TOWN OF MILFORD

Administrative Review

Date: January 3, 2021
To: Jason Plourde, Chair, Zoning Board of Adjustment
From: Lincoln Daley, Community Development Director
Subject: **Case #2021-16: Gretchen Davidson for the property located at Milford Tax Map 48, Lot 43, 64 Federal Hill Road - Variance Application (Continued from 12/2/21)**

Aerial Photos of Subject Property:

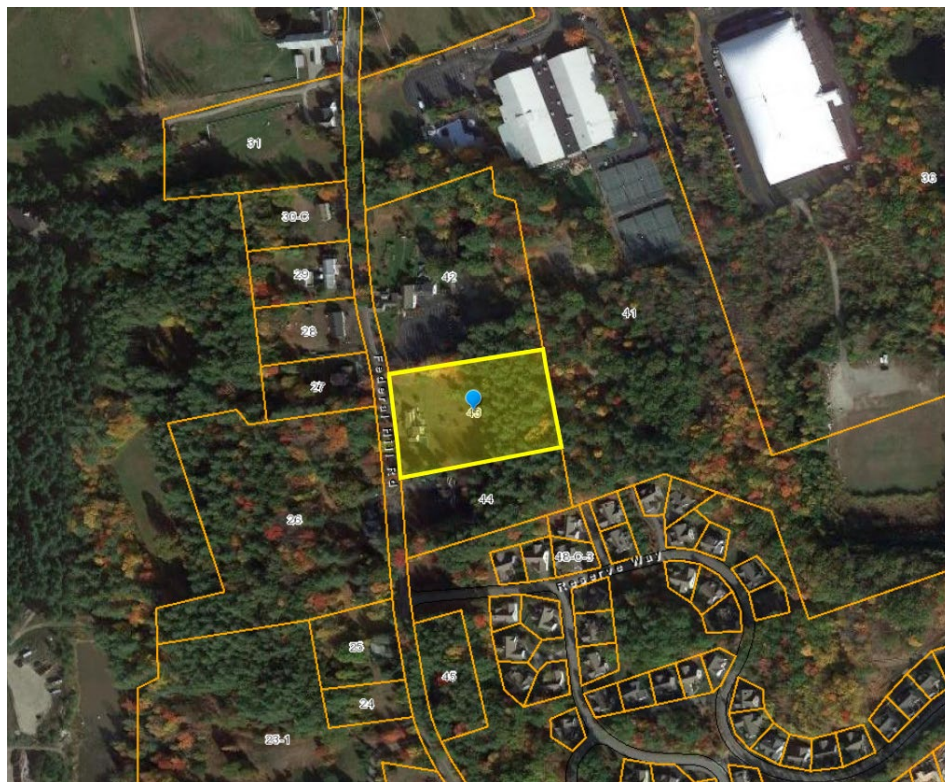
1. Existing Conditions:
 - a. The subject property is approximately 2.5 acres in area and contains a 5 bedroom, single-family house located on front part of the property just beyond the 30 foot front dimensional setback. The property is primarily undeveloped and is serviced by a private well and septic.

- b. The property contains more than 273 linear feet of frontage and accessed by two curb cuts on Federal Hill Road
 - c. The subject property is situated in an established residential area and commercial area. To the west the subject property is Zoned Residential 'R' and consists of single-family homes on properties varying in size (one acre and larger). To the north and west, consists of the Mile Away Restaurant (Map 48, Lot 42) and Hampshire Hills Club (Map 48, Lot 41). To the south, the properties are Zoned Residential 'A' and include single-family residences (including the Reserve).

2. The applicant is seeking to subdivide 1.3 acres from the parent lot, Map 48, Lot 43 (totaling 2.5 acres) to create Tax Map 48, Lot 43-1. The proposed lot would have 60 feet of frontage on Federal Hill Road and be accessed from the existing paved driveway. With the exception of frontage for the proposed new lot (Tax Map 48, Lot 43-1), both lots would meet the minimum dimensional requirements for a parcel in the Residential "A" Zoning District (40,000 square feet and 150 feet of frontage) not serviced by municipal water and wastewater.

5. The section of roadway in front of the subject is classified as a state road falling under the responsibility of NHDOT. As such, a NHDOT driveway permit is required for the new proposed lot and subdivision process. It is staff's understanding that the applicant and representatives continue to work with NHDOT to obtain said driveway permit.

ZONING BOARD OF ADJUSTMENTS EXHIBIT

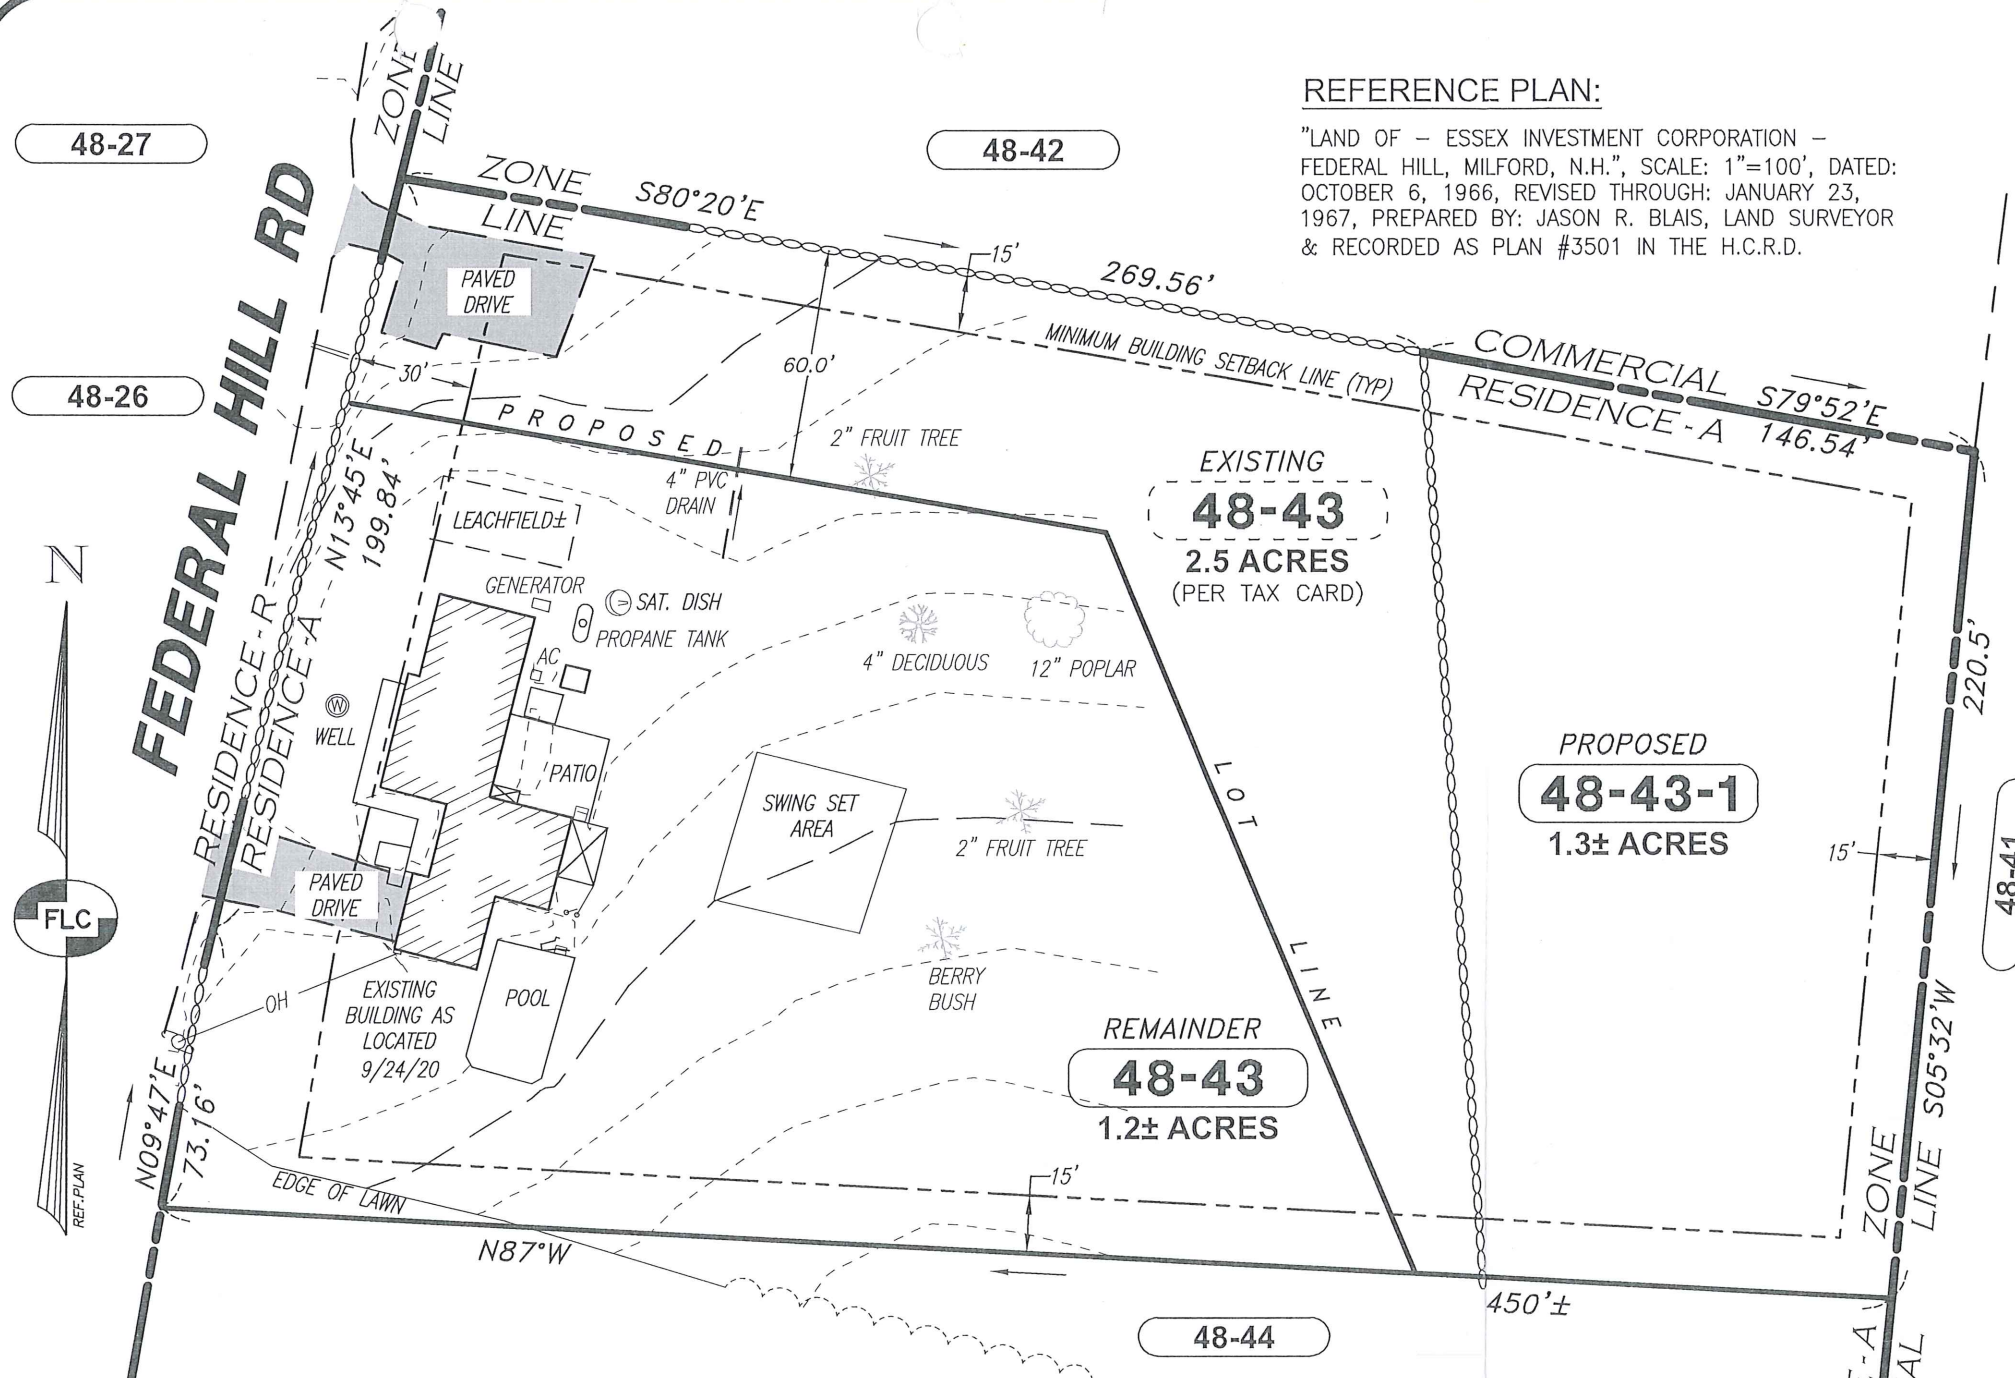
5. Unnecessary Hardship:
The Zoning Board of Adjustment Exhibit attached identifies the unique features of the property. The existing home and lot improvements are located along the westerly property line. The property is oversized in comparison with the required 40,000 square

The Zoning Board of Adjustment Exhibit Plan attached identifies the unique features of the property. The existing home and lot improvements are located along the westerly property line along Federal Hill Road. The existing driveway to the north will complement the proposed new lots access. The property consists of 2.5 acres with 273 feet of frontage. All other infrastructure is in place and adequate. This proposal is consistent with the surroundings and will therefore not alter the essential character of the neighborhood. To require literal enforcement of the ordinance will not provide any gain to the public or the neighbors and would restrict the applicant's ability to develop the property in harmony with its surroundings resulting in unnecessary hardship.
